October 17, 2022

RE: **Lot 25 Block 6 Volcano Cliffs Unit 2 SAD 227
8024 Kibo Dr. NW
Grading and Drainage Plan
Engineers Stamp Date 10/11/2022 (E10D122)**

DRAINAGE AND TRANSPORTATION INFORMATION SHEET (REV 6/2018)

8024 KIBO	DRAWN BY WCVJ
	GRADING AND DRAINAGE PLAN	DATE 10-10-22
10/11/22		20220070-LAYOUT-10-10-22
DAVID SOULE P.E. #14522		SHEET #
		JOB # 20220022

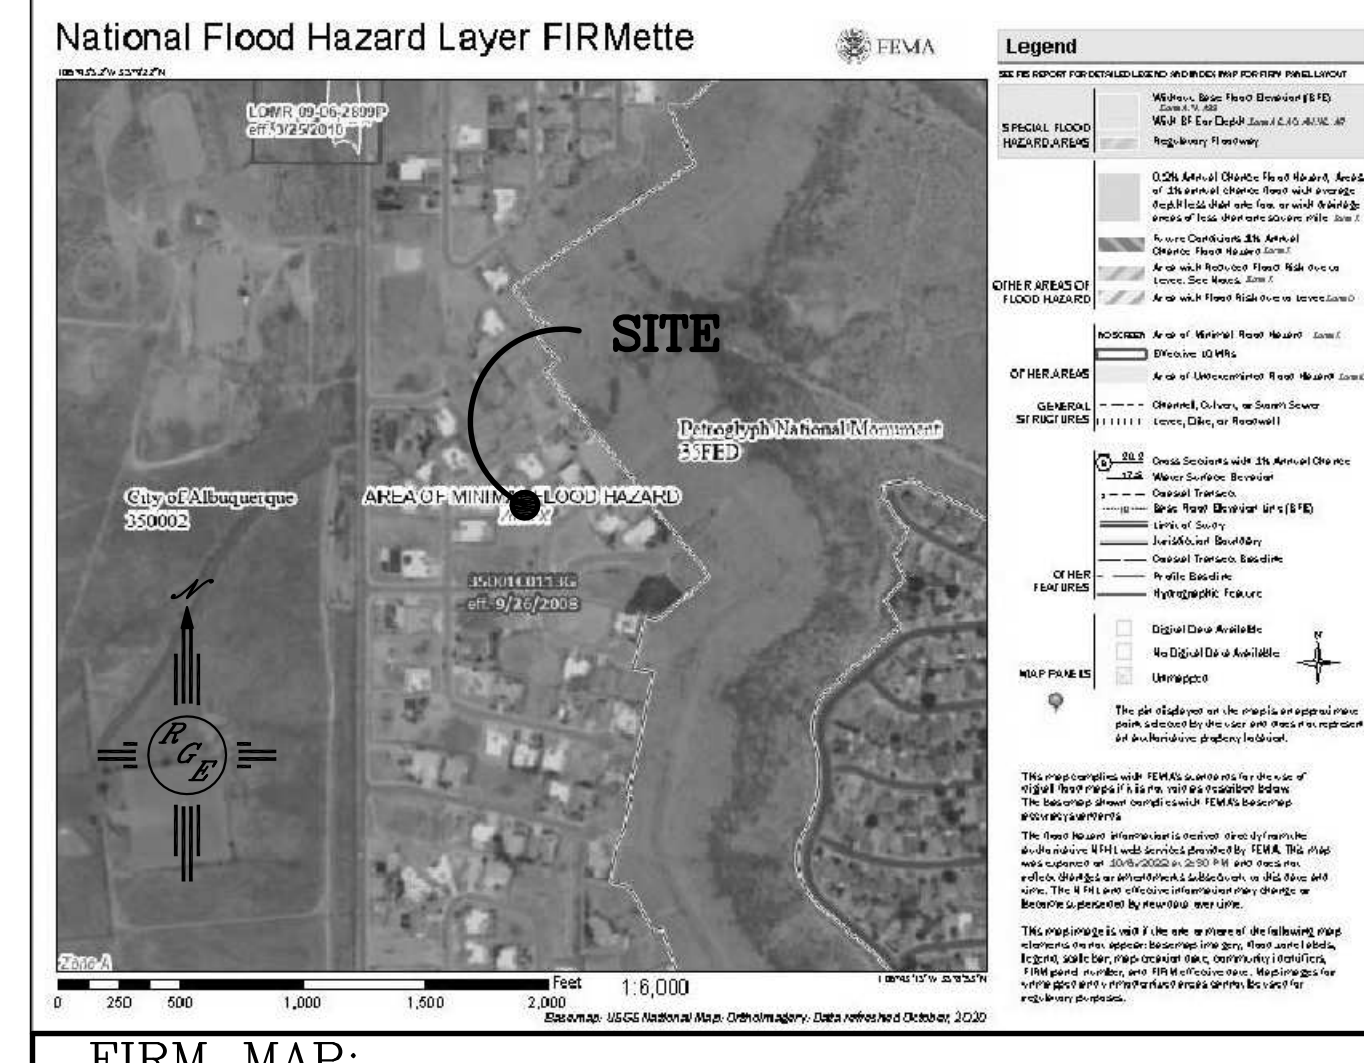
Based upon the information provided in your submittal received 10/14/2022, this plan is approved for grading permit.

Reiterate to the Owner/Contractor that a separate permit for a garden/retaining wall must be obtained, with the approved G&D plan and Pad Certification. Inform the owner & Contractor that dirt is not allowed in the public right of way to climb the curb. Crusher fines or lumber is allowed. If dirt is used this will delay going forward with the construction of the home.

Prior to Certificate of Occupancy release, Engineer Certification per the DPM checklist of this plan will be required.
